## Planning Commission Staff Report

Case No.: 5.1137 PD – 335; TTM 35230 and 3.3028 –MAJ.

Application Type: Planned Development District; Major Architectural Application, and Tentative Tract Map

Location: 300 South Palm Canyon Drive at the southeast corner of South Palm Canyon Drive and Baristo Road

Photo 1: Looking south from street, view corridor to the mountains is framed by palms.

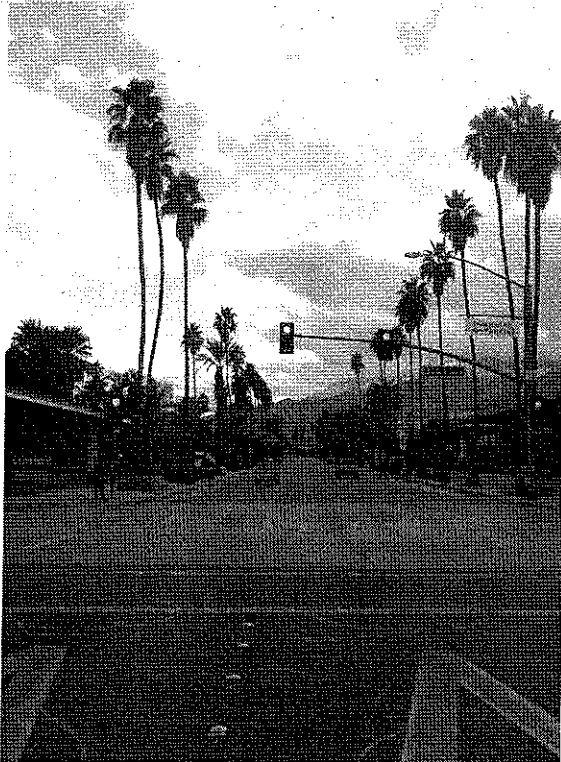
*(DUDP Page 37) Building massing should step back above the ground floor to maintain and protect public view corridors along streets.*

The General Plan does not provide a specific dimensional requirement for stepping back a building's upper floors to protect public view corridors. Along this section of Palm Canyon Drive, Mexican Fan Palms line both sides of the street and establish a visual 'vertical edge' to the north-south view corridor. These trees frame the southward view corridor to the mountains as shown from the street in Photo 1 below. Behind the palms, on the sidewalk side, the view of the mountains is obscured by palm tree skirts and other vegetation as shown in Photo 2. Although roughly half of the building's frontage is at the front property line, the building remains 'behind' the vertical edge of the view shed established by the palm trees and thus does not obscure or impact the public view corridor along Palm Canyon Drive, either from the street or the sidewalk.

Photo 2: Looking south from the sidewalk in front of 300 South Palm Canyon, no view corridor exists because palm skirts and other vegetation obscure the view.

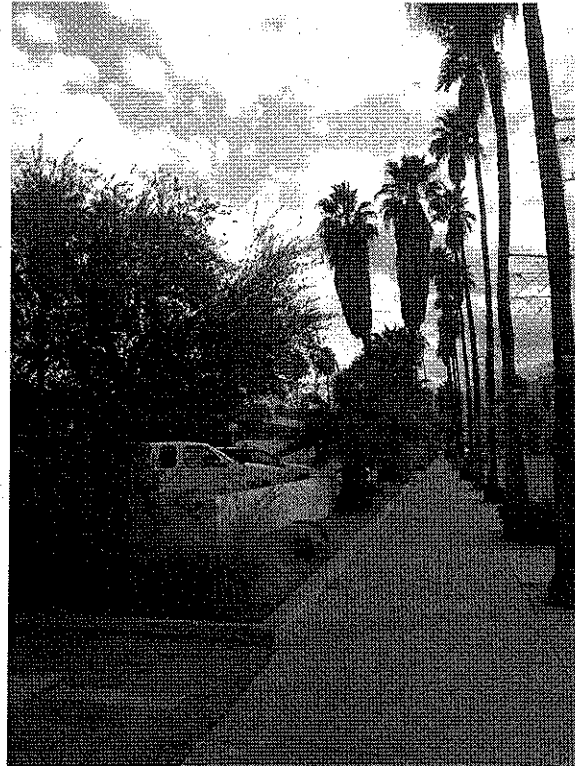
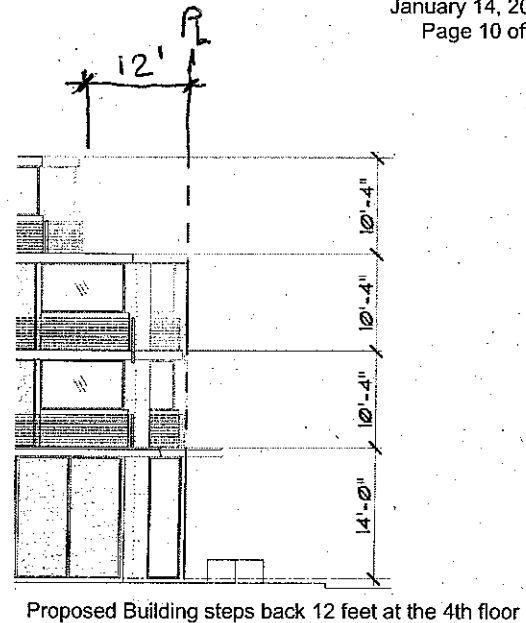
The project is somewhat consistent with the step-back concept statement because the building massing steps back away from the street at the fourth floor. Staff believes however, that the issue of step backs to protect the view corridor is moot because the view corridor does not exist on the sidewalk side of the line of palm trees along Palm Canyon Drive. Views of the mountains from the sidewalk are effectively blocked by palm fronds and other vegetation. The actual view corridor, seen from the street, will not be impacted by the proposed new building. The proposed horizontal shading device will limit upward-oriented views from the sidewalk, but also will not impact public view corridors toward the mountains.

**NORTH ELEVATION**  
SCALE: 1/8"=1'-0"

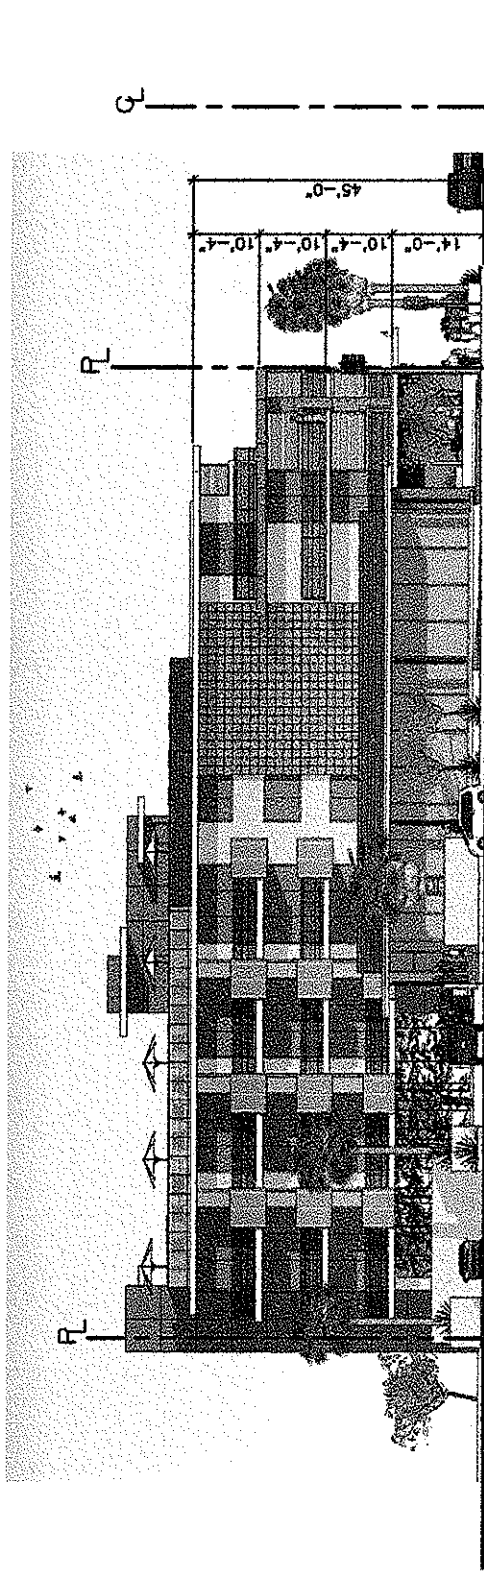
- Revise the balconies on the north elevation of the proposed high-rise to be "Juliet balconies" to provide more space between the existing and proposed new building.

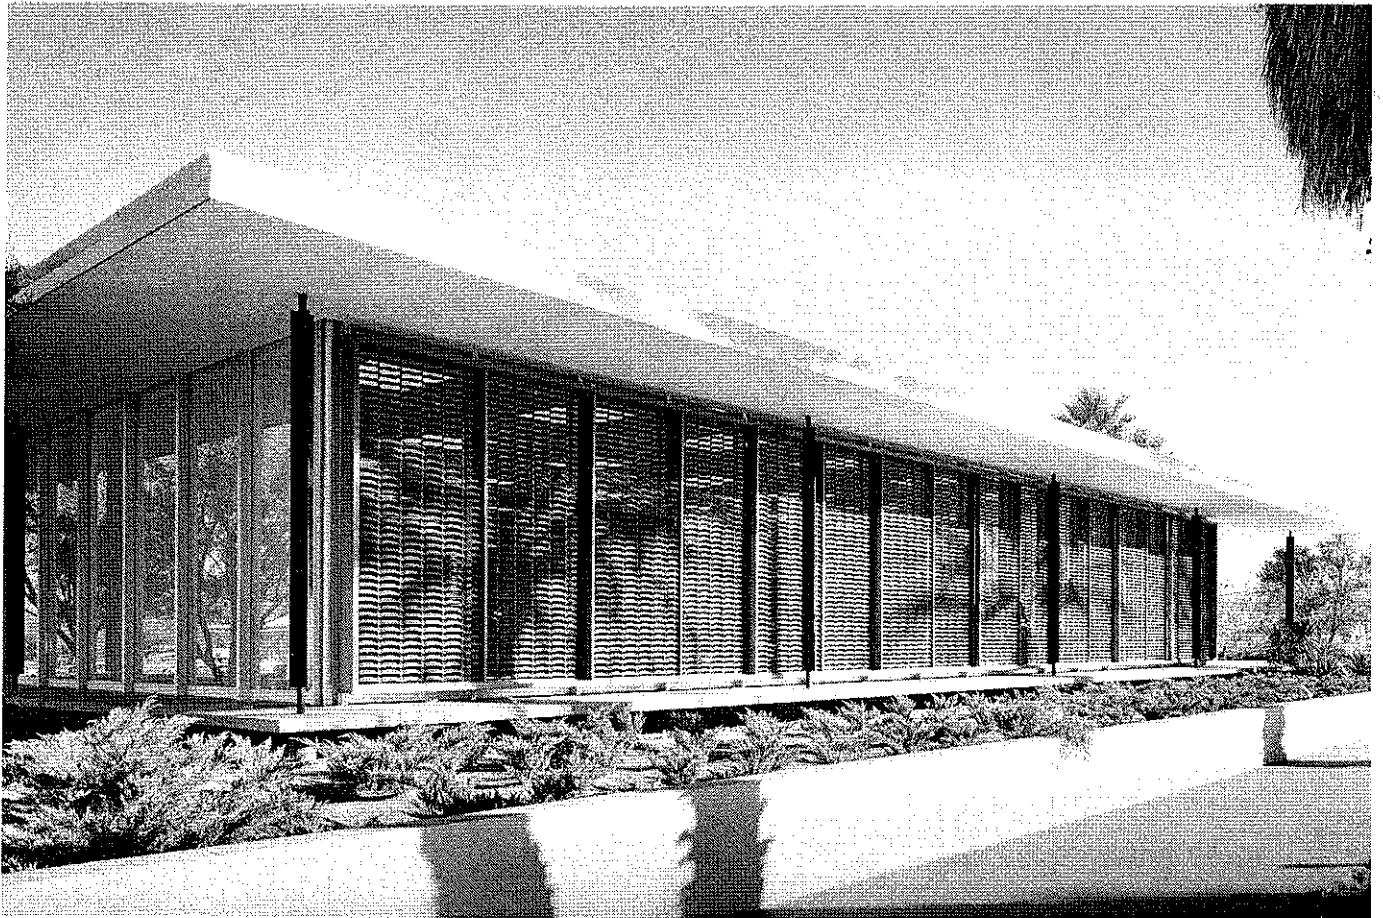
The Julius Shulman photo you provided with your letter is taken at the southwest corner of the site. From this vantage point, the adjacent drive aisle rises in elevation to just below the top of the plinth or podium and ties in with a wide entry stair that terminates the cantilevered edge detail of the podium on the south elevation. However additional Shulman photos (included herein) taken from the northwest show the cantilevered edge clearly visible above the landscape and the (now removed) retaining wall at the perimeter of the site. It is at this northwest corner - where the cantilever and floating appearance is most visible - that the proposed dining terrace is proposed. The original slump stone retaining wall could indeed be replicated, but it is not considered a defining historic characteristic. It also does not appear that doing so would ameliorate the need for railings on the proposed dining terrace as suggested in your letter.

From the evidence in these photos and other materials, the City has concluded that the proposed dining terrace would materially alter the characteristics of a historic resource at this site.
